ADDENDUM NUMBER 1

**Professional Development Center
and Kitchen**

For
SAN BERNARDINO CITY UNIFIED SCHOOL DISTRICT
Bid No F16-05

December 28, 2015

CHK'D BY:

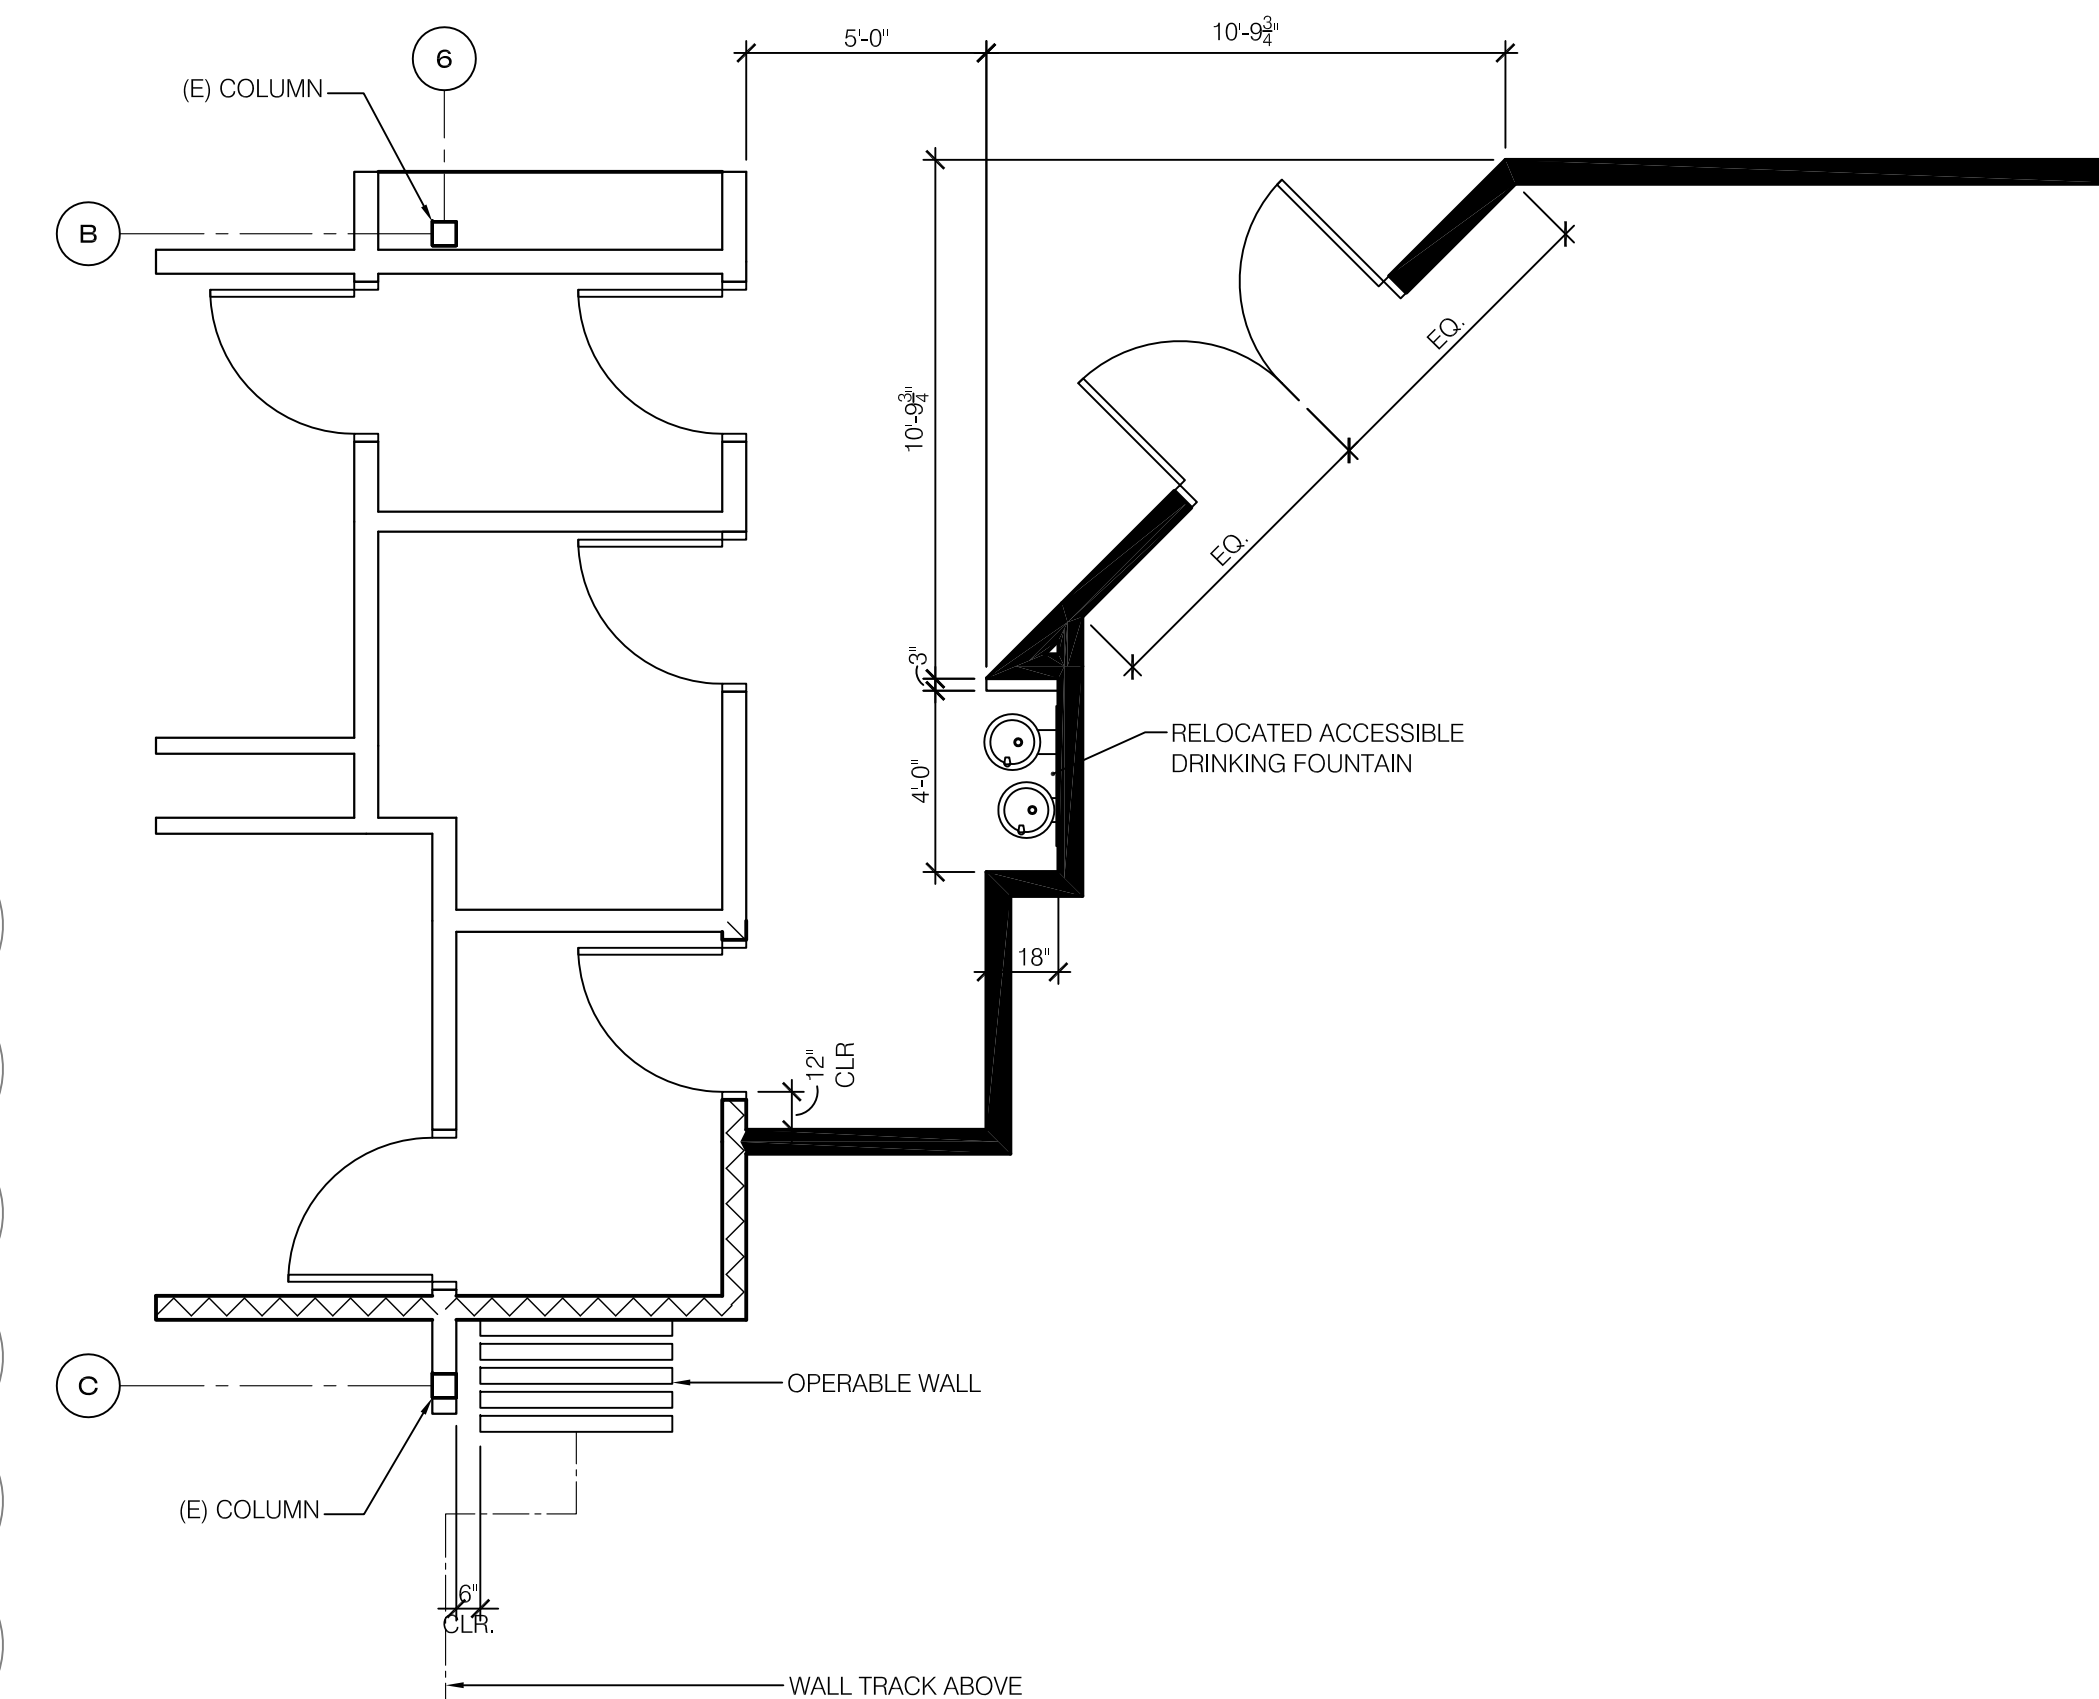
Item Number 22; Reference: Sheet A-5, Second Floor Demolition Plan; Replace this sheet with attached sheet **A-5, Second Floor Demolition Plan.**

Note: Revised sheet provides clarification of demolition work and relocation of existing dual drinking fountain

SECOND FLOOR
REFLECTED CEILING
PLAN

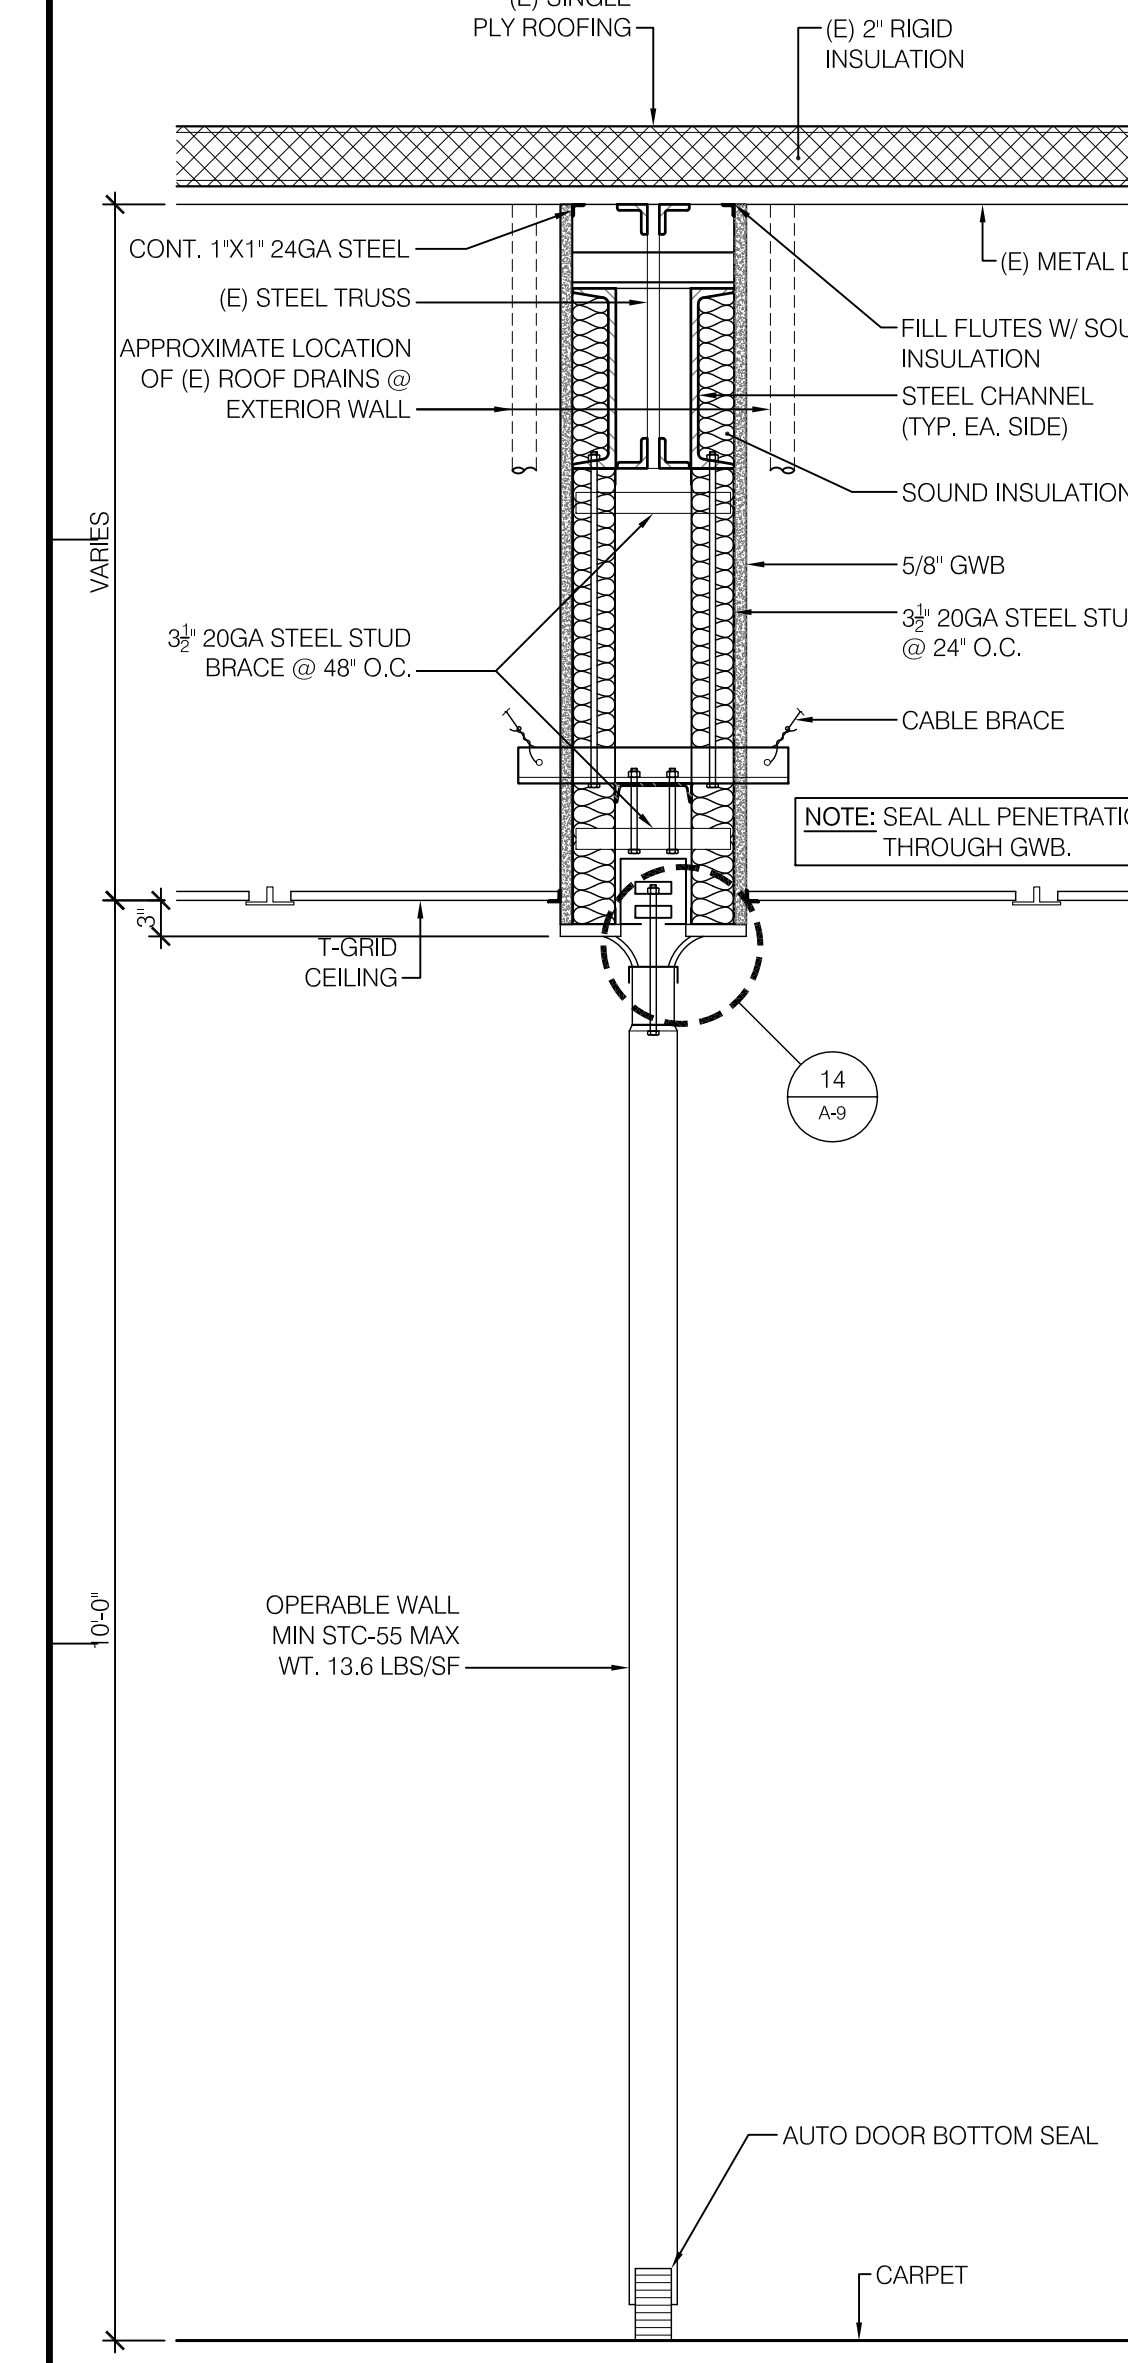
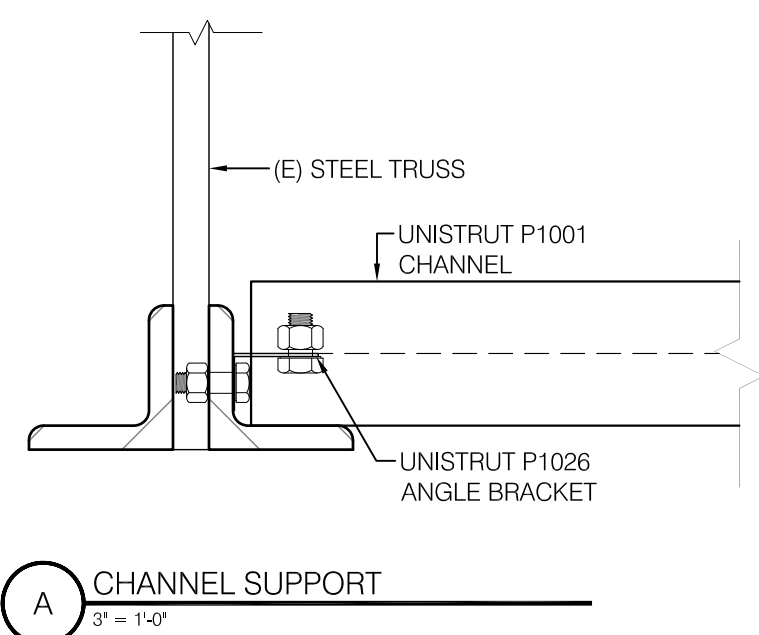
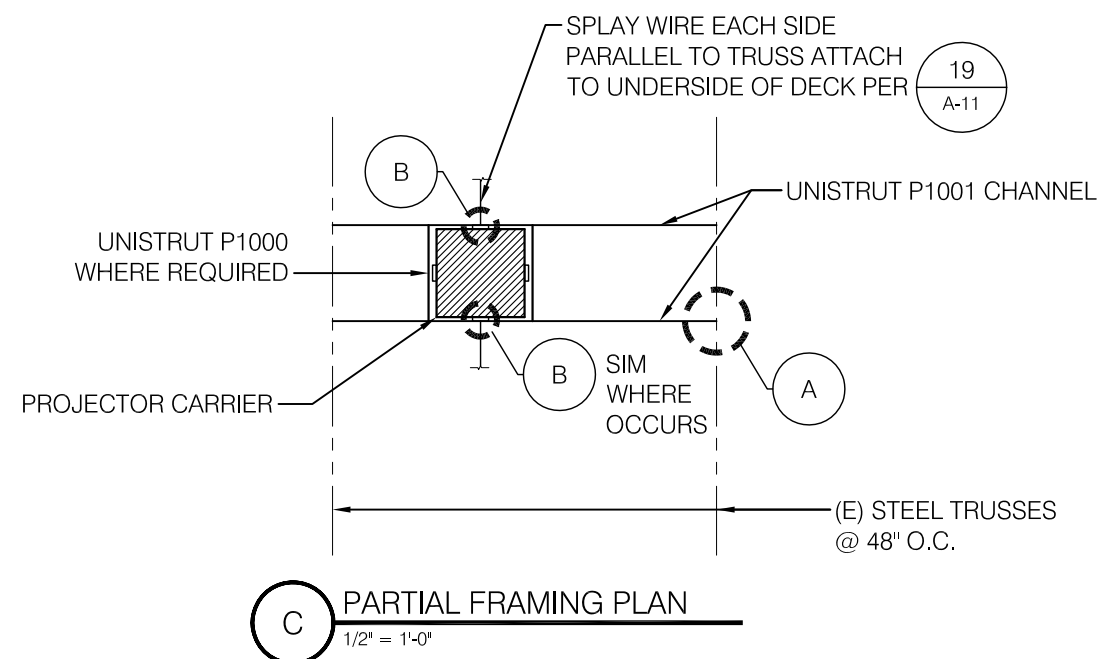
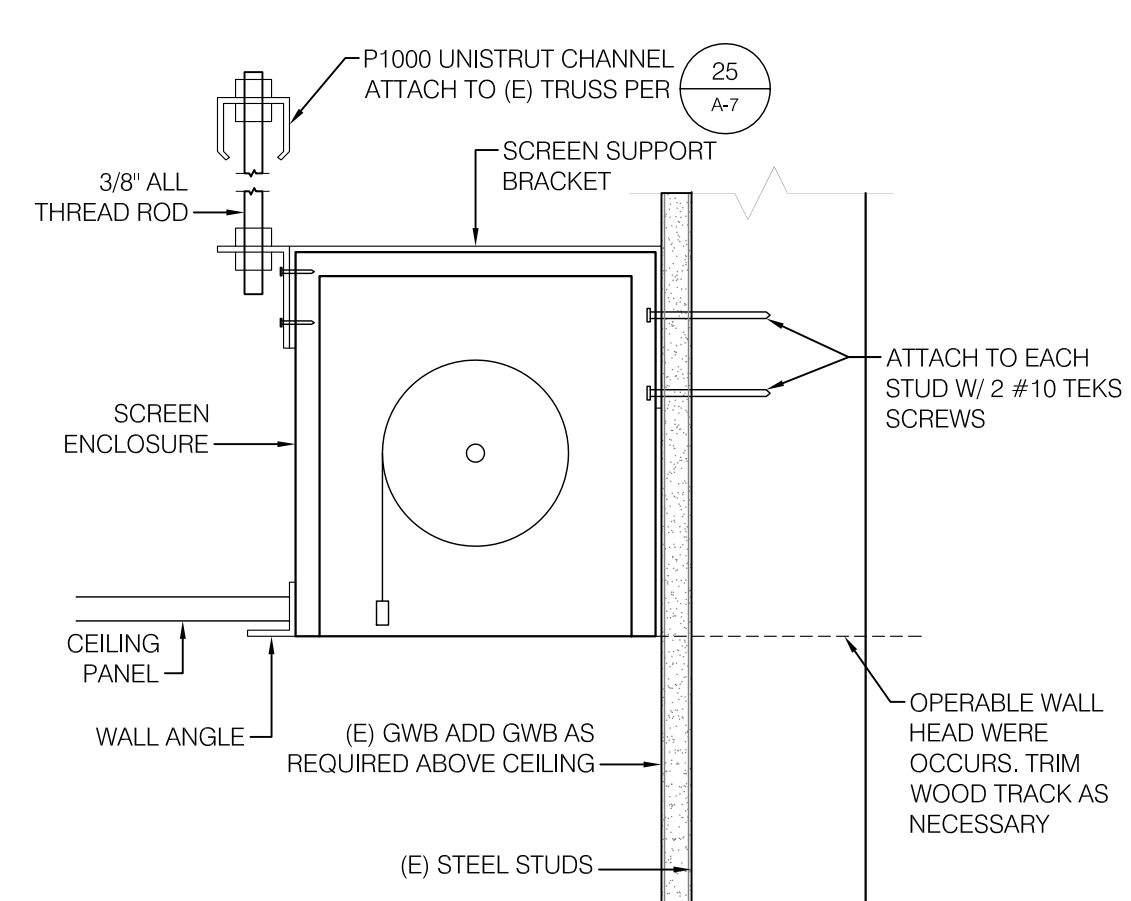
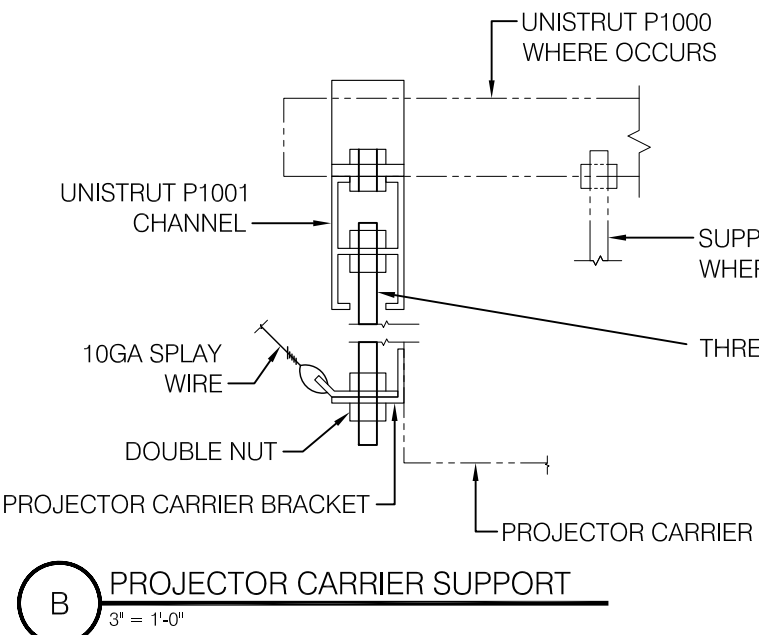
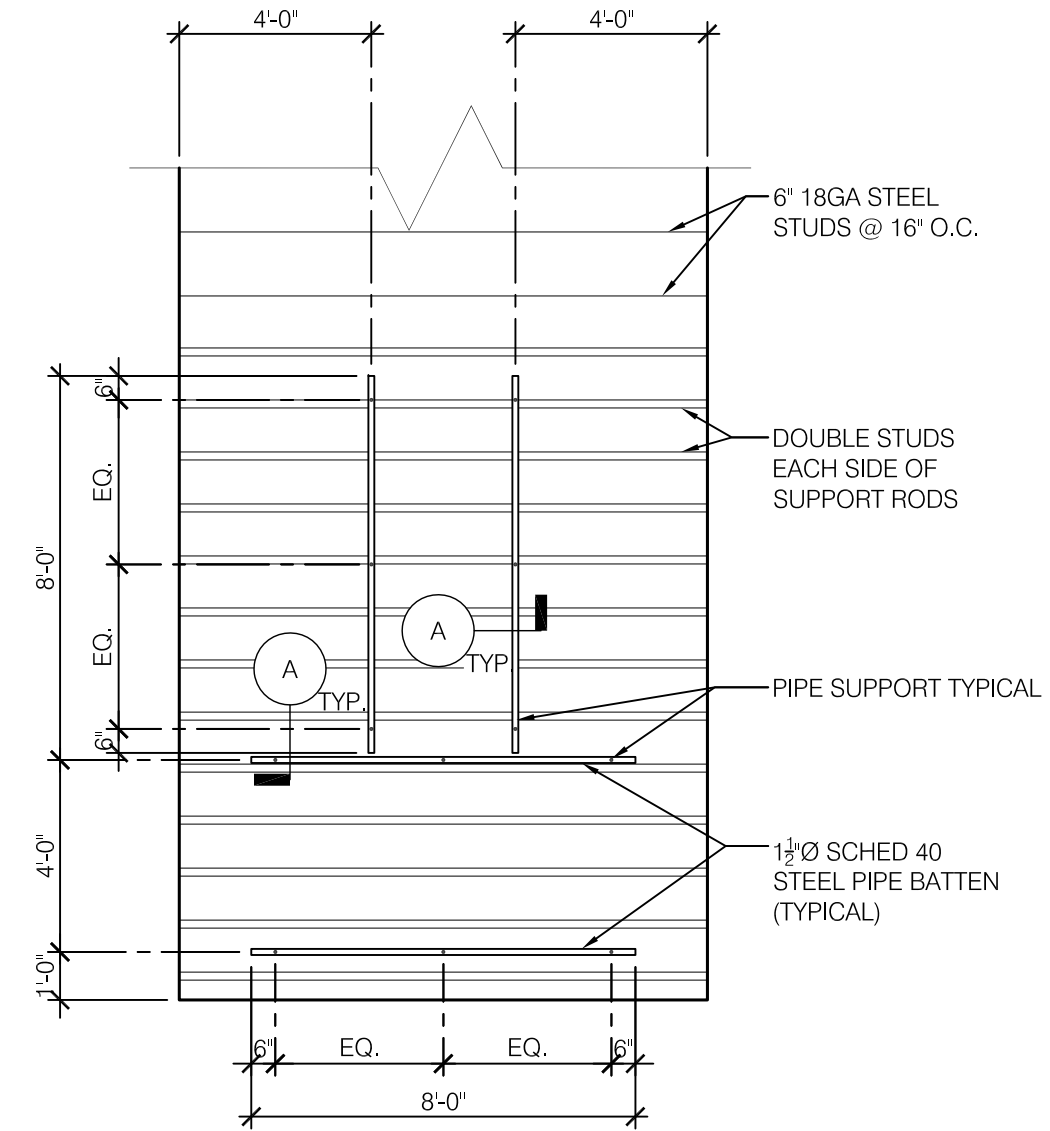
Item Number 24; Reference; Sheet A-7, Second Floor Reflected Ceiling Plan; Replace this attached sheet with sheet **A-7, Second Floor Reflected Ceiling Plan.**

Note: Revised sheet provides revisions to AV/Studio 208, Storage 205, adds General Notes and adds details 25, 27 and 28.
